Bulletin

Saab

9-3

Loss of coolant

Figure 1
(Old layout)

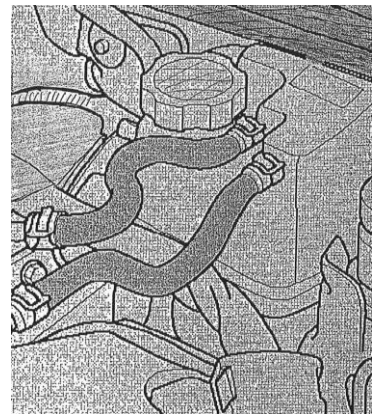
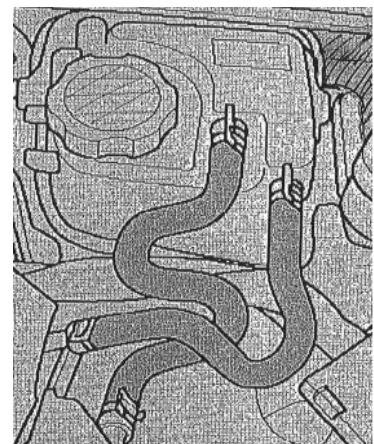
In the case of the above-mentioned vehicles, problems can arise because of loss of coolant. The cause of this can either be a defective coolant expansion tank or damaged engine coolant hoses on the coolant expansion tank. The positioning of these components (Figure 1) is located very close to the turbo charger, which means that material fatigue can result because of the hot ambient temperature.

In order to remedy this, the coolant expansion tank is to be replaced and the hoses of the coolant expansion tank are also to be replaced / repositioned.

The car manufacturer provides modified coolant hoses for this specific purpose (See Figure 2).

Spare part no: 93 194 927
- 1*set engine coolant hoses

Spare part no:12 759 330
- 1*Coolant expansion tank.
